Reliability Analysis Update

Sub Regional RTEP Committee - PJM West

June 15, 2021

Changes for Existing Projects

Project B2883 Revision (Presented in 4/17/2017 and 5/31/2017 SRRTEP)

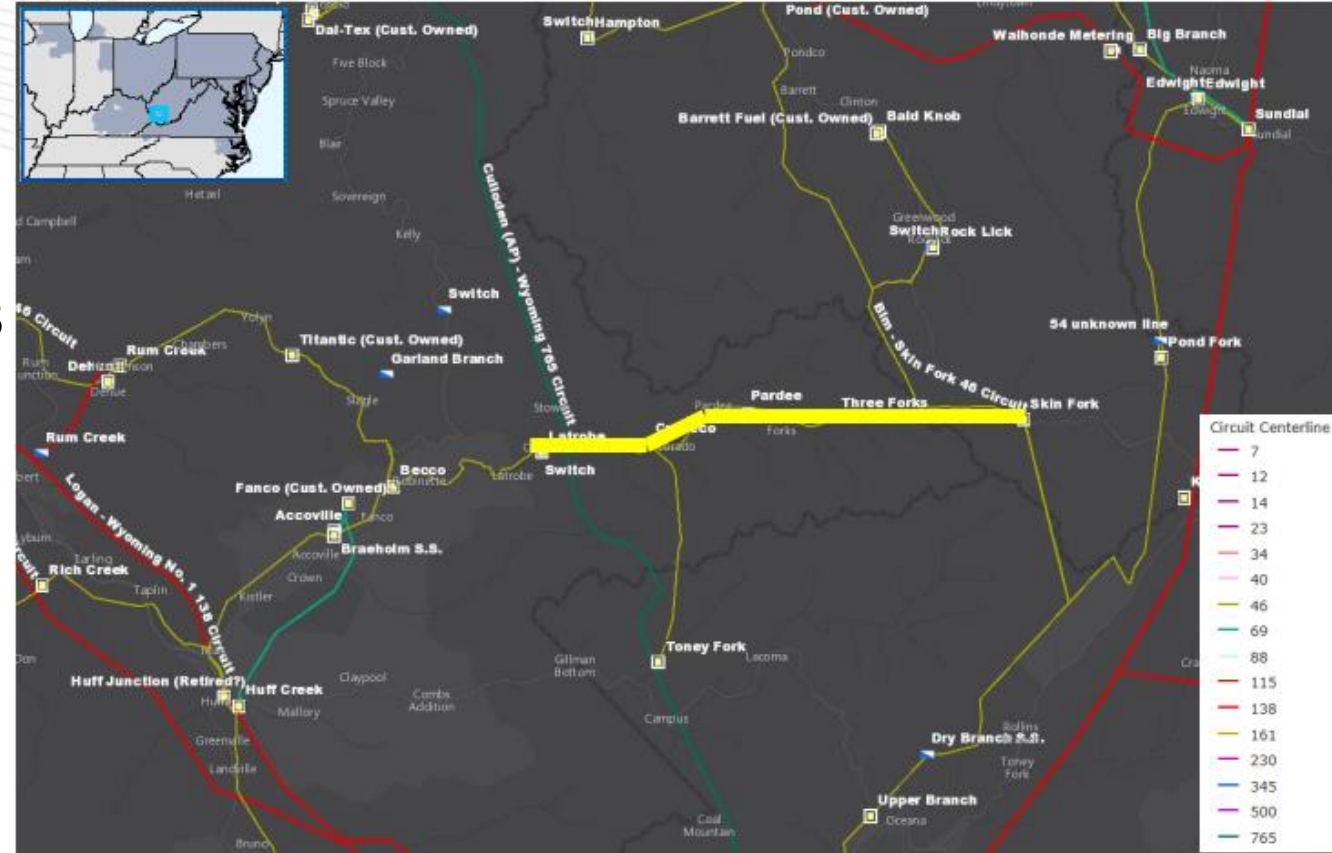
B2883: Rebuild the Craneco – Pardee – Three Forks – Skin Fork 46kV line section (approximately 7.2 miles) utilizing 795 26/7 ACSR conductor (108 MVA rating, 43%).

Major Reasons for Cost increase:

- Due to the complexity of the project and difficult terrain, construction bids came in higher than original estimates.

- Delay due to inability to secure required easements through the condemnation process in time for work to continue without demobilization. Costs encompass remobilization and some temporary work to keep line in service during delay. An additional complication was added with the closure of WV courts in response to the COVID pandemic.

- Encountering excessive access road rock & excessive rock drilling costs above anticipated amounts based on available soil borings.

- WVDEP requirement on enhanced SWPPP including increased inspection intervals and enhanced environmental barriers. Recent change to state regulations.

- Non-topology changes identified in detailed design to Station Scopes resulted in additional costs associated with station work at Lacey's Branch, Skin Fork and Becco stations. These changes include relay panel changes, the addition of SST/CTs/CCVTs, rock adders and scope for testing and commissioning.

- Non-topology changes identified in detailed design to Line scopes resulted in additional costs which include changes in foundation designs, distribution relocations, steel tariffs, and bat studies.

New Estimated Transmission Cost: \$42.2M

Projected IS date: ~~4/1/2018~~ 11/30/2021

Project B2603 .1 - .3 Revision (Presented in 1/7/2015 TEAC)

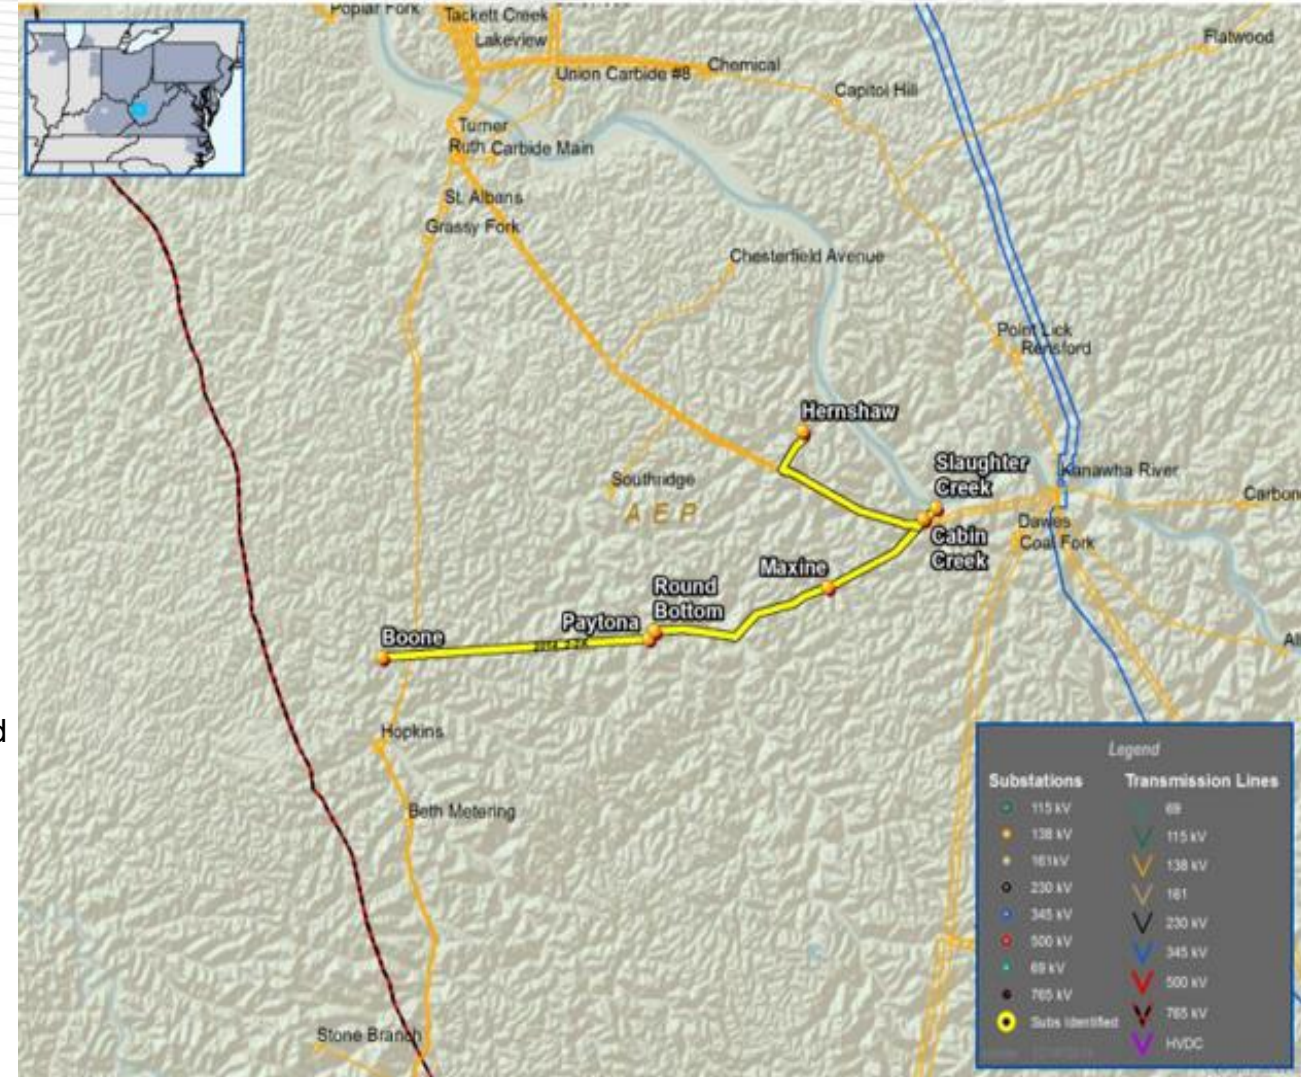
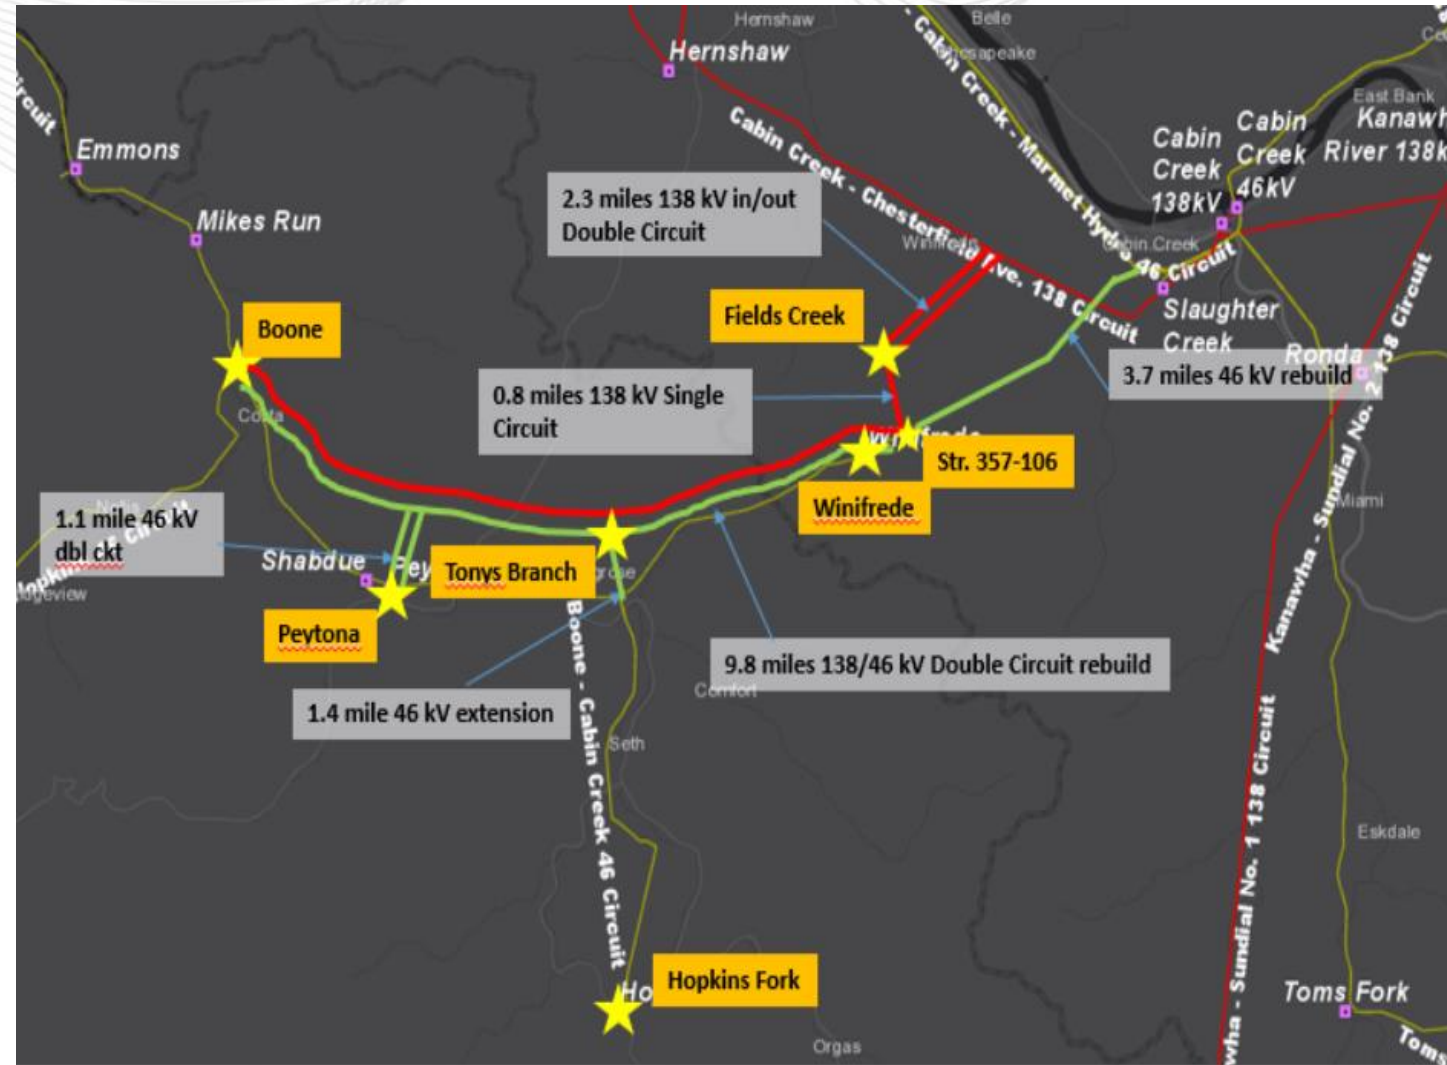
- B2603 .1- .3 was in 2014 RTEP window #2. It was proposal P2014_2-2K, which was the only proposal received to address the AEP 715 violations on the Slaughter Creek –Winifrede 46kV line overloads and low voltage issues at the Emmons, Round Bottom, Peytona, Penn VA Coal, Mikes Run, Shabdue, Hopkins Fork, Boone, Maxine S. S., Camp Creek 46kV buses.

- **B2603.1:** Purchase approximately a 200X300 station site near Slaughter Creek 46 kV station (to establish a greenfield 138kV Wilbur Station). Install 3 138 kV circuit breakers,
- **B2603.2:** Loop the Cabin Creek to Hernshaw 138 kV circuit into the new station by constructing ~1mile double circuit 138kV line extending north from the station
- **B2603.3:** Construct 15.86 miles of 138 kV double circuit line using 1033 ACSR 54/7 conductor and 1-2#8 alumoweld and one 86 Sq.MM. 0.646" OPGW Static wires with one conductor side insulated at 138 kV and one side insulated at 69 kV. Connect 46 kV line insulated to 69 kV to Slaughter Creek, Maxine, Peytona, Round Bottom and Boone Stations. Add 138-69/46 kV 130 MVA Transformer and circuit switcher to Boone Station. Add 69 kV 40 kA 3000 amp circuit breaker operated at 46 kV.

- **Transmission Line Tension changes to Increase life Span (\$342K):** Tension requirements were decreased by using a different standard causing some engineering and material changes. These changes increase conductor life span when they transverse the longer spans necessitated in the West Virginia mountains.

- **Varying quantities of steel and conductor and type foundations needed due to differing conditions encountered. (\$2.13M):** The Boone Area Reinforcements Transmission Line design was adjusted based on landowner required changes and obtaining detailed geotechnical data.

- **Reroutes of approximately 3 miles (\$7.183M):** Reroutes of an approximate total amount of 3 miles to accommodate landowner requests, avoidance of encroachments, and slide prone areas that caused the center line route to be adjusted.

- **Bat Survey (Loaded \$302K):** A bat survey was necessary to avoid additional mitigation costs during construction.
- **Reroute of approximately 1.5 miles (\$ 2.72M):** This approximate 1.5 mile reroute made outage accommodations possible so the line could be rebuilt within outage window constraints.

- **T-Line Alignment change at Entrance to Fields Creek (\$751K):** Land owner would not allow a structure on their property so the T-line entrance had to be moved from original engineered position. This move required additional dead ends to allow for proper clearances.

- **New Access Requirements (\$3.04M):** New access routes were required due to DOH (WV Division of Highways) bridge being built in the area and mining efforts in the area. Access roads had to be moved because a DOH permit was denied and ongoing mining activities encroached on the proposed access making those routes no longer possible.

- **Danger tree removal costs (\$1.30M):** Costs for clearing danger trees in the area of the T-line. A danger tree is a tree outside our defined ROW that poses the risk of falling into the T-line.

- **T-Line Grounding Extra costs \$2.39M):**Two ground rods were driven but acceptable ground reading was not achieved. A ground-well configuration was engineered and implemented in order to allow for proper grounding on the line.

- **Boone East ROW Delay (\$510K):** Delay due to inability to secure required easements through the condemnation process in time for work to continue without demobilization. Costs encompass remobilization and some temporary work to keep line in service during delay.

- **Unaccounted for rock at drilling and grillage sites (\$3.66M):** Encountering excessive access road rock & excessive rock drilling costs above anticipated amounts based on available soil borings.

- **Slide Remediation Work (\$3.5M):** Terrain and excessive rain caused landslides, and in some cases construction of access roads and clearing of trees for Transmission line clearances.

- **Additional Drill Shaft Foundation efforts due to unknown subsurface issues (\$222K):**The impact associated with mitigating subsurface latent conditions that could not be detected by soil boring analysis or other methods.

- **B2603.1:** Establish a new greenfield 138kV station at **Fields Creek** which is located 2.3 miles from the existing line Station location (changed from the original proposed site at Wilbur, Near Slaughter Creek Wilbur) .Install 3 138 kV circuit breakers

- **B2603.2:** Loop the Cabin Creek to Hernshaw 138 kV circuit into the new **Fields Creek** station by constructing ~2.3 mile double circuit 138kV line extending north from the station

- **B2603.3:** Construct 15.86--9.8 miles of 138 kV double circuit line using 1033 ACSR 54/7 conductor and 1-2#8 alumoweld and one 86 Sq.MM. 0.646" OPGW Static wires with one conductor side insulated at 138 kV and one side insulated at 69 kV from **Boone** substation to **Structure 351-11** on the **Belle – Cabin Creek No.1 46kV** line. Connect 46 kV line insulated to 69 kV to **Slaughter Creek**, **Winifrede**, **Maxine (Tonys Branch)**, **Peytona**, **Round Bottom** and **Boone** Stations. Add 138-69/46 kV 130 MVA Transformer and circuit switcher to Boone Station. Add 69 kV 40 kA 3000 amp circuit breaker operated at 46 kV. Rebuild the 3.7 miles 46kV circuit from the **Structure 357-106** to **Slaughter Creek**. (The original plan proposed rebuilding Boone – Wilbur on the existing centerline. The current plan is rebuilding off centerline, which drove additional scope:) Build back a double circuit extension (1.1 miles) back to existing switches at **Peytona** as well as the addition of a new extension to a new switch at **Tonys Branch** (replaced existing **Maxine** switch). Rebuild the 1.4 miles 46kV single circuit to connect the existing line to **Hopkins Fork** to the new **Tonys Branch** Switch. Replace two 46kV switches at **Winifrede** 46kV Station:

New Estimated Project Cost: \$114.5M
